NEDC-33922P-A, Revision 3,
BWRX-300 Containment Evaluation Method

NEDO-33922-A
Revision 3
June 2022

BWRX-300 Containment Evaluation Method

SUBJECT: FINAL SAFETY EVALUATION FOR GE-HITACHI LICENSING TOPICAL REPORT NEDC-33922P, REVISION 2, "BWRX-300 CONTAINMENT EVALUATION METHOD" (DOCKET NO. 99900003)

Figure 2-1: BWRX-300 RPV and Internals

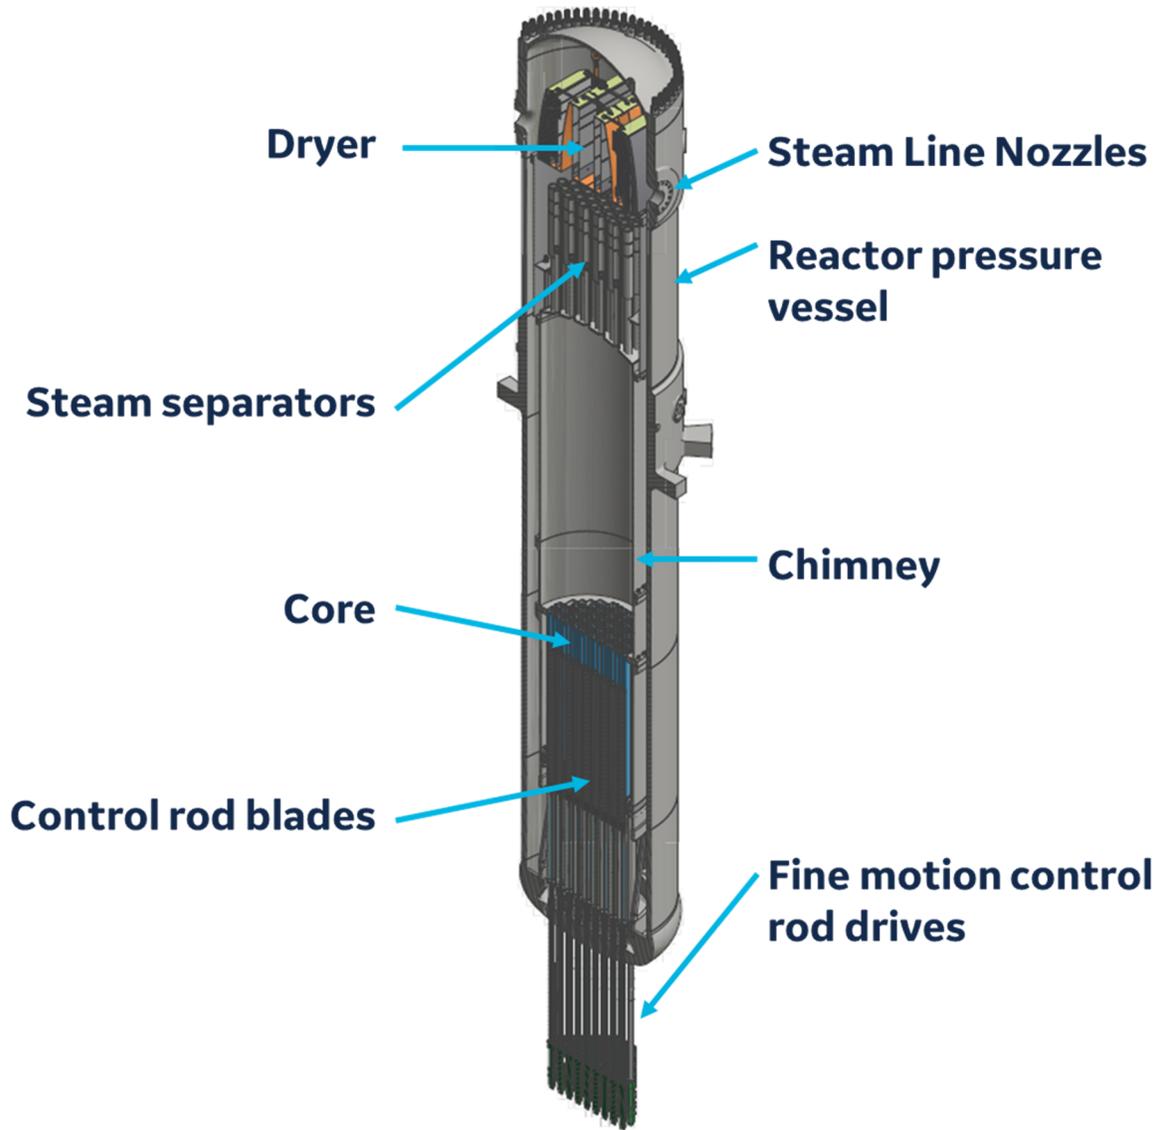
The BWRX-300 RPV and internals are shown on Figure 2-1 and described in Reference 7.1. The Isolation Condensers (IC) are also described in Reference 7.1 with illustrations included on Figure 2-2 and Figure 2-3. As described in Reference 7.1, all piping [[

Figure 5-2: TRACG RPV Nodalization

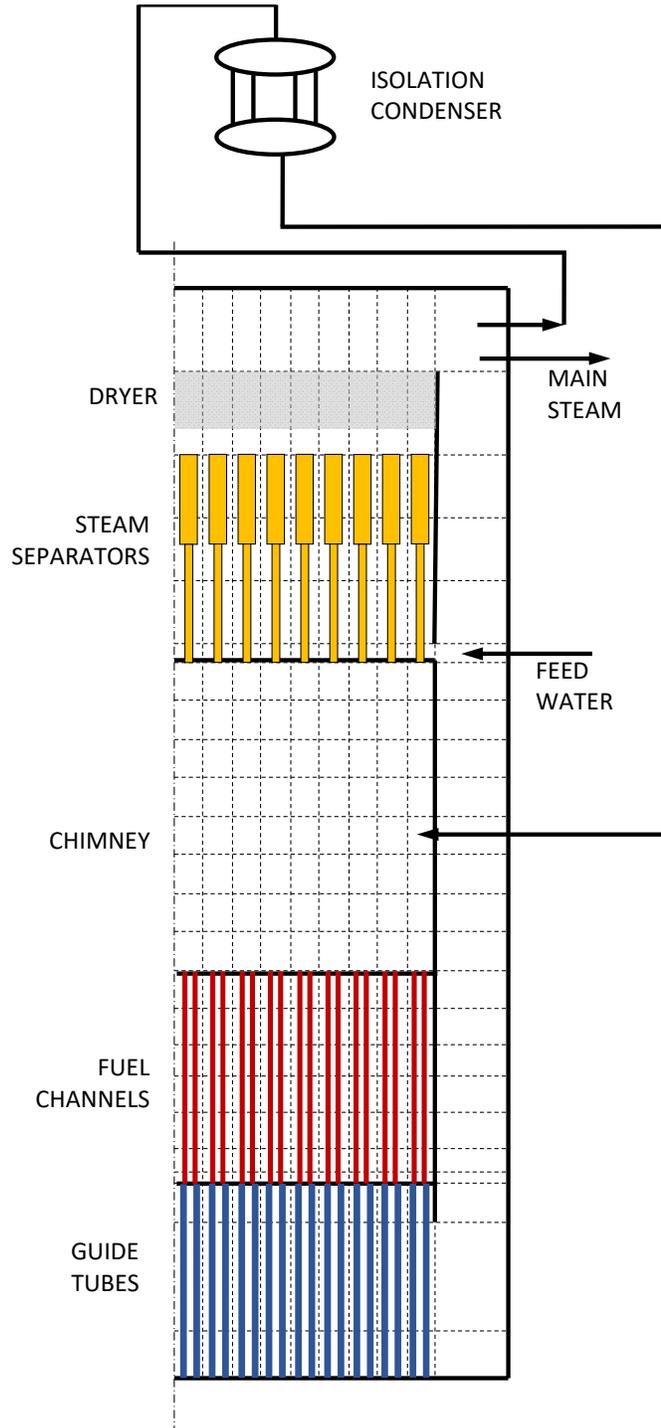
Main feedwater pumps, isolation valves and specific piping segments are used to model inlet piping at the elevation near the top of the chimney as shown in LTR Figure 5-2. [[
